Melksham Link

Wiltshire Council Planning Application ref. W/12/01080/FUL

Supplementary Report

January 2019

Figure 1 – Melksham Link: new weir at Challymead

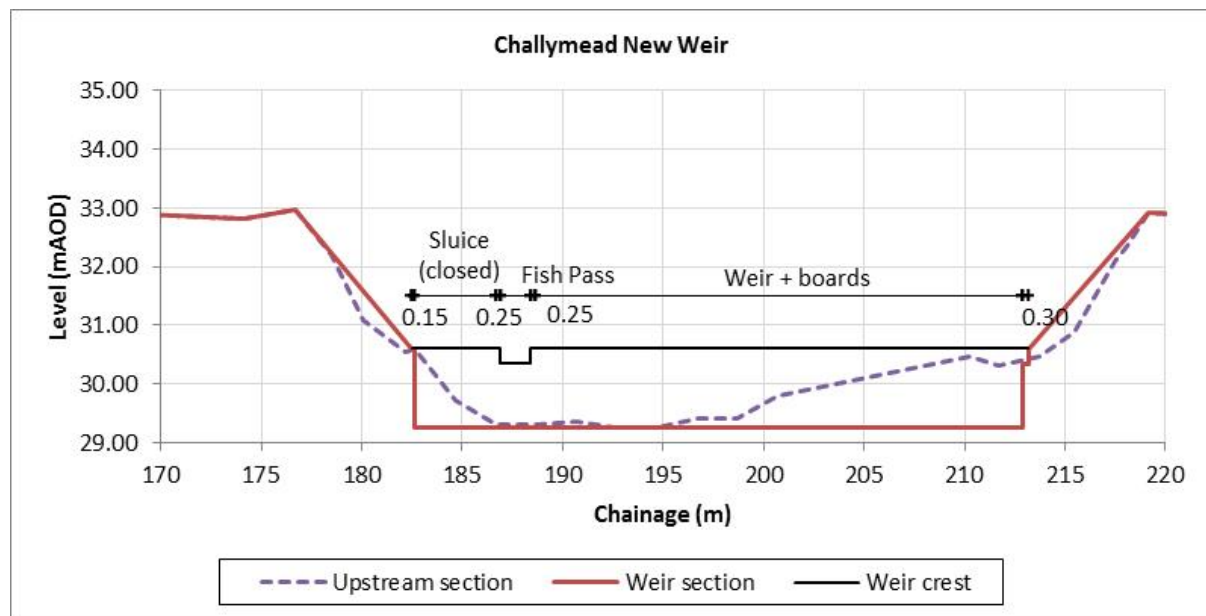
If the new weir has a crest level of 30.60 and the upstream water level is 30.65, it is suggested that there will be a 2cm increase (p.3-10, 1st bullet) in levels under the 2-lock operation. What does this equate to in flow downstream of Challymead weir?

1. **Weir Crest Level** - Referring to point i) in our letter of 12 May 2017 – drawing WBCT/10/017 rev 7, WBCT-10-32 (appendix 4) and WBCT-10-033 (appendix 4) all show the concrete weir crest level to be 30.35mAOD and the crest level of the drop-in boards to be 30.60mAOD which will retain upstream water levels at that figure. A level of 30.60mAOD is also stated in table 2 (p.3-6). We recall that the modelling we have reviewed used a level of 30.35mAOD. If the weir crest level is to be 30.60mAOD, modelling will need to be re-run and re-reviewed by the Environment Agency using this crest level.

The proposed weir crest is at 30.60mAOD, with the boards in place. To maintain the conveyance, the training bank construction is assumed to be excavated from the river bed so the cross-sectional area of the watercourse does not change. This will ensure that the introduction of the training bank will not reduce the conveyance of the River Avon through the town.

Figure 1 shows the cross section of the proposed weir. The training bank location and a typical cross section are shown in Figure 2.

Figure 2 – Training Bank Reach

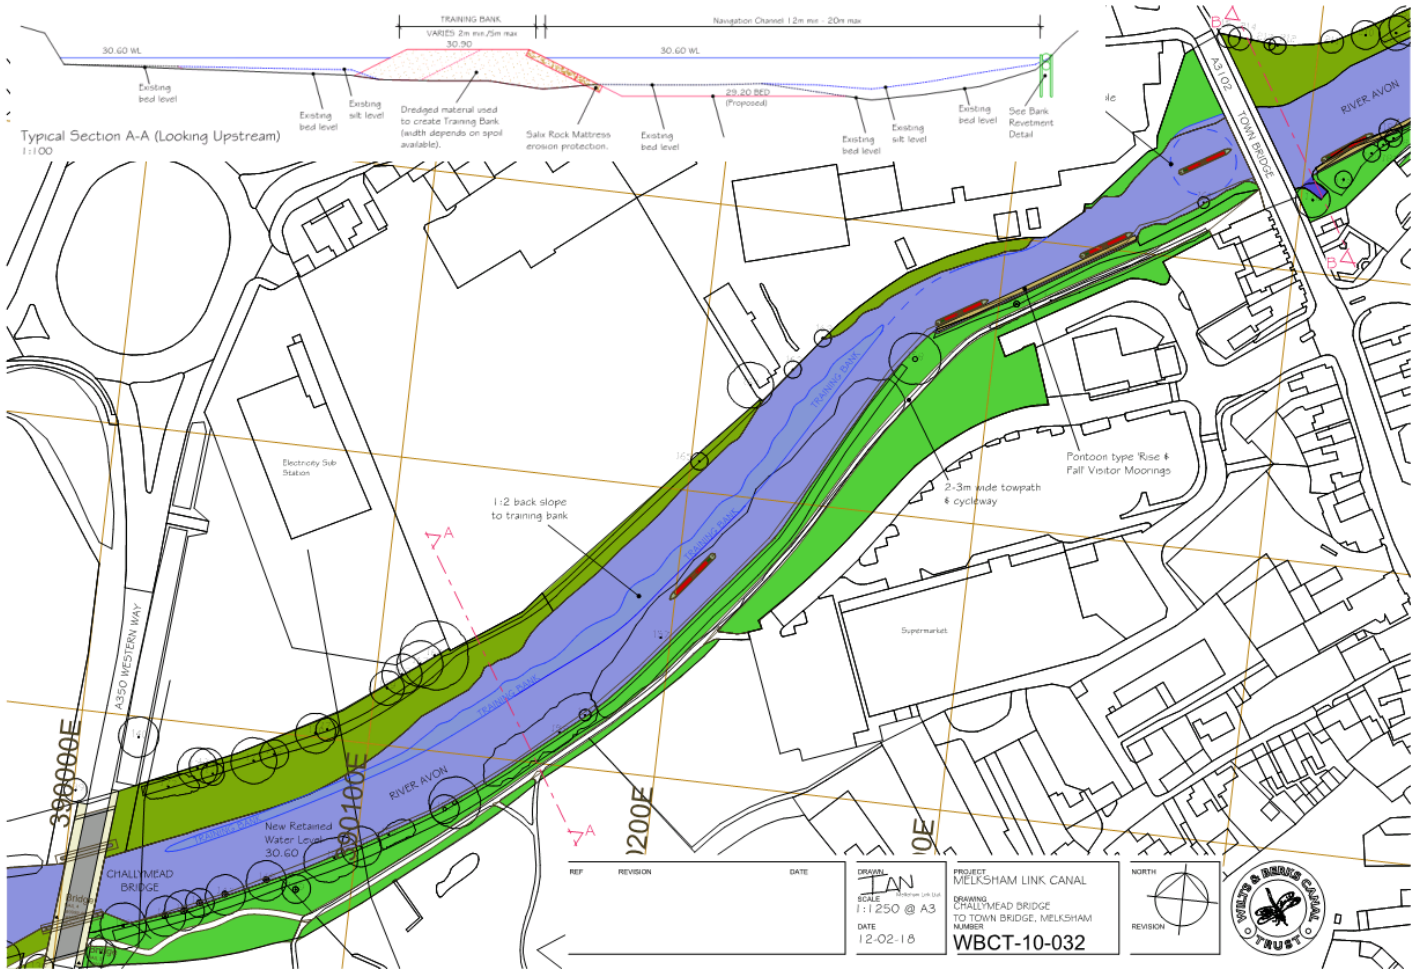
The proposal to construct a training bank through the newly impounded reach is a new design feature of this application. The oversized and artificial cross-section of the channel in this reach would support channel narrowing as a form of restoration and we agree with the recent geomorphological survey that, from an ecological perspective, creating a two-stage channel that allows for naturalization of the right bank has merit. While the report states that there will be no impact on channel capacity, because the volume of the training bank will be achieved from the excavation of the bed in the navigation channel, this makes the assumption that over time the right bank will not become heavily vegetated to the extent that conveyance is reduced.

There are a number of construction issues with the training bank, that require addressing for this element to be acceptable from an ecological perspective, for example:

1. How will the wet bed sediment be held in place to create a stable bank and prevent a major silt release impacting the natural downstream channel?
2. What assessment has been made of the existing bed sediment to assess its suitability for use in creating a stable bank?
2. How will the upper surface of the bank be protected from scour under high flows when inundated?

The new design element of the training bank will need to be included within a revised FRA to ensure no impact on flood levels and for this to be a realistic test this assessment should allow for significant vegetation (including trees) to become established on the right bank. In addition, it should be noted that Section 4.4 describes some aspirational future environmental enhancements to the training bank and Town Bridge reach, all of which would further impact the flood conveyance properties of the reach.

Table 2 shows the flood levels for higher roughness on the non-navigation channel. In this test it is assumed that the roughness coefficient (n value) in the non-navigation part of the channel is increased from 0.045 to 0.06. An n value of 0.06 is relatively high (representing significant areas of weed) and would not be expected to be exceeded with appropriate maintenance. There are small differences (1cm) in flood levels for the higher roughness results in some limited flows. This analysis shows that the flood levels on the River Avon are relatively insensitive to increased roughness in the non-navigation channel.

Figure 4a – Water levels and flows in River Avon

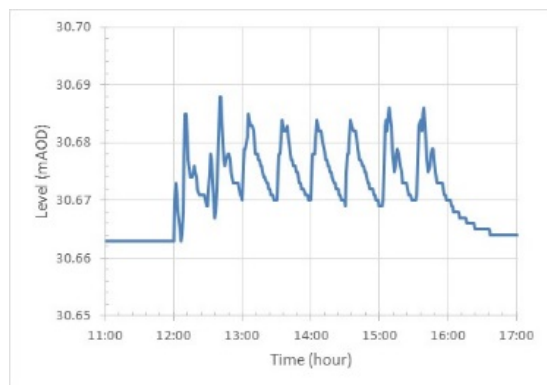
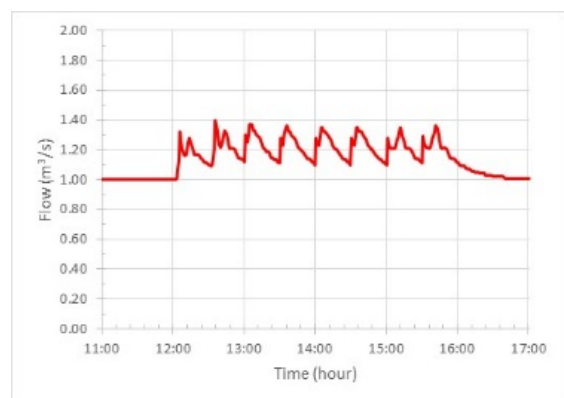
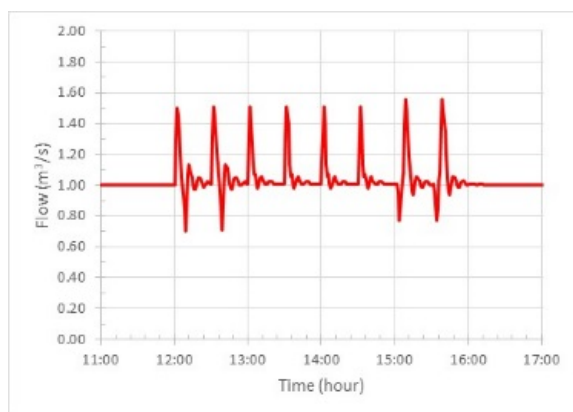
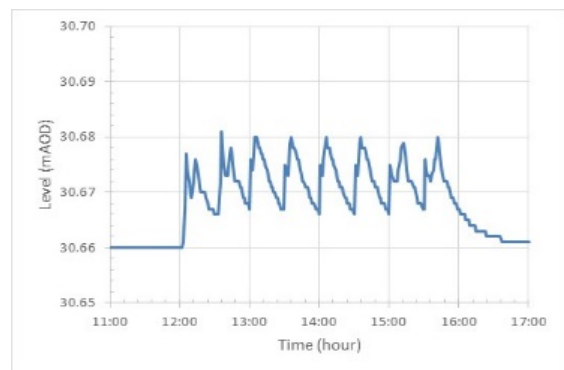
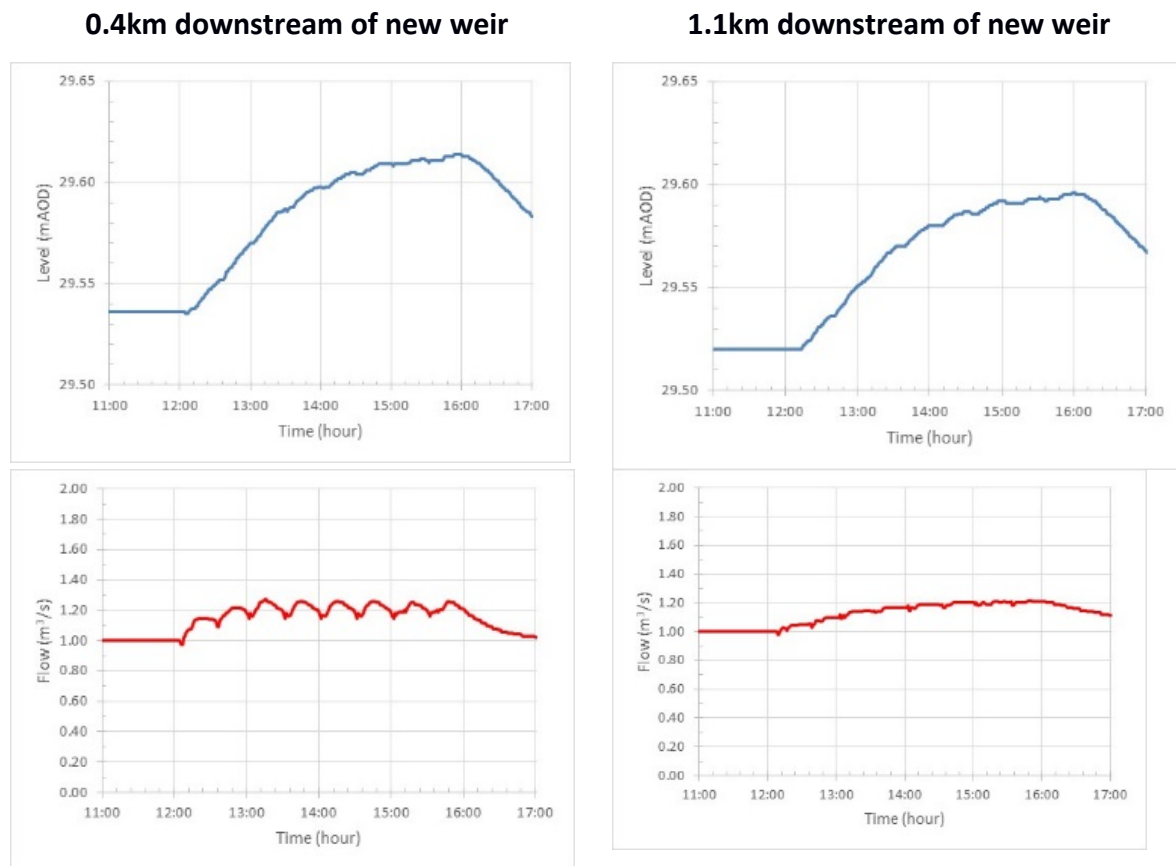
It is unclear how there can be a drop in level Fig 7 (3) (p.3-11) with the downstream lock operation.

Section 3.4 of the ES Addendum Report (March 2018) does not address the potential impact of potential flow pulsing on flow regime downstream of the proposed new weir. The report only considers the potential change in water levels at Town Bridge within the heavily modified and proposed impounded reach. The channel downstream of the proposed new weir is relatively natural in terms of its channel form and flow characteristics and it is this reach in particular that an impact assessment is required for. Modelling the impact within an impounded and over-wide rectangular reach will obviously underestimate the potential impact in the relatively natural downstream channel and without further information on this issue our objection remains in place.

Appendix 3, Table D1 states that the hydrological regime downstream of the proposed new weir remains unchanged – this statement does not reflect the potential for flow pulsing as noted above. According to the analysis presented in Section 3.4 of the ES Addendum Report the maximum instantaneous rate of lockage discharge from Lock 2 would result in a doubling of the Q95 natural river flow and it is the impact of this on the natural downstream channel that requires assessment.

Model results are summarised in Table 8. Figure 4 shows the water level and flow plots in the River Avon. These show that:

- The change in water levels is negligible (2-8cm) because of the large storage capacity in the river relative to the locks. The change in velocities is very small (0.01m/s).

- The inevitable pulsating nature (20mm) shown on Figure 4 is from operation of the locks. In reality, the shape of the hydrographs will be different depending on the lockage time and back-pumping of the locks. During peak times it is estimated that the lockage could occur every 15 minutes and the back-pumping could be continuous¹.

- Downstream of the new weir the pulsating nature identified upstream of the weir is essentially absent. This is because the weir routes the flow, i.e. the storage capacity of the reach upstream of the new weir and the hydraulic characteristics of the weir dampens out the 'spikes' that are observed upstream. With back pumping the gradual rise in water levels shown (albeit only 80mm) is unlikely to occur as the change really reflects the additional flow coming from the locks. In any case the maximum rate of rise of about 35mm/hour in water level is very small, compared to natural variation.

- In higher flows than the Q95, any impact on levels due to the locks is unlikely to be noticeable.

Figure 6 – Berryfield Brook, floodplain upstream of culvert flood level 36.85m

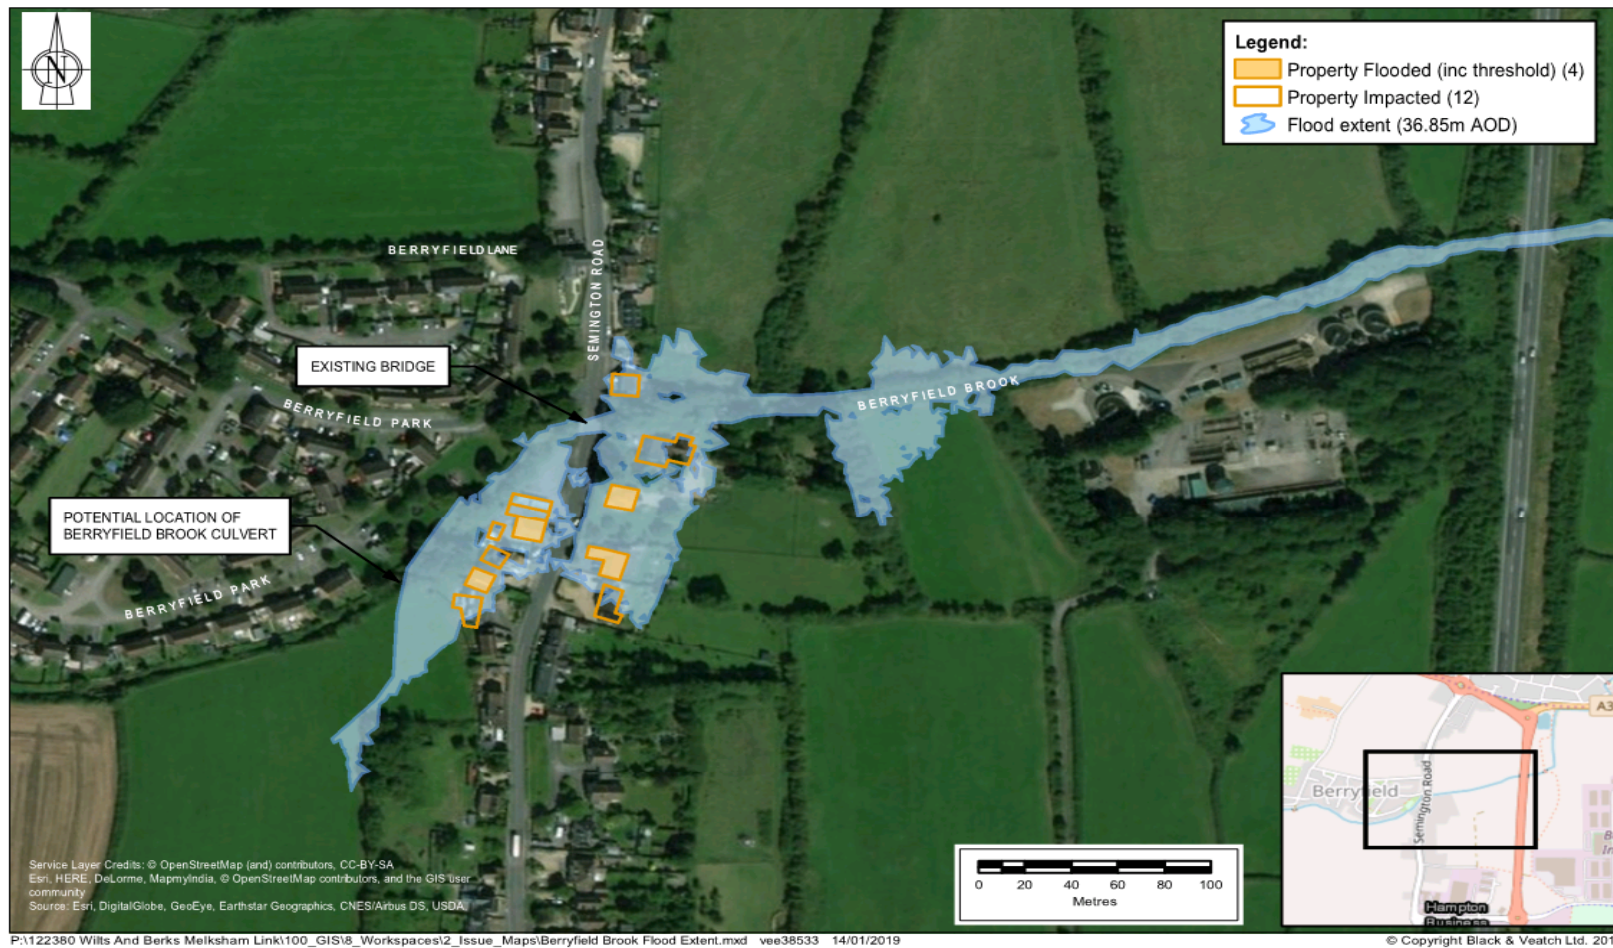
2. **Culvert Blockage** - Regarding point iii) of our letter of 12 May 2017, the recent submissions still do not provide illustration of what land will be flooded in the event of blockage of the Berryfield Brook culvert (where the canal is proposed to cross over Berryfield Brook). There are properties/land in between Semington Road and Berryfield Brook which could be at an increased risk of flooding from culvert blockage. We need to see a graphic illustration (i.e. a map with illustrations) of what area is likely to be flooded for the different blockage scenarios which have been discussed in Appendix 3.2, page 7.

The construction of the proposed canal and culvert would potentially increase the flood risk in the area, but only if there is a blockage of the culvert. In order to minimise this risk, it is now proposed that the level of the coping on the upstream side of the canal be lowered to 36.85 AOD along a 30m length above the culvert to provide a route into the canal for flood water (see figure 5).

WBCT has been asked to provide an illustration of the flooding implications of a total blockage of the culvert and this is given in figure 6. This illustrates the floodplain extent upstream of the culvert with a flood level of 36.85m AOD and shows that potentially 4 properties could be flooded above threshold in this scenario and a further 8 would be surrounded with water.

By comparing the two maps (figures 6 and 7), it can be seen that the areas at risk are very similar. Even with a total blockage, the flood risk to the area would not significantly increase as a result of the development.
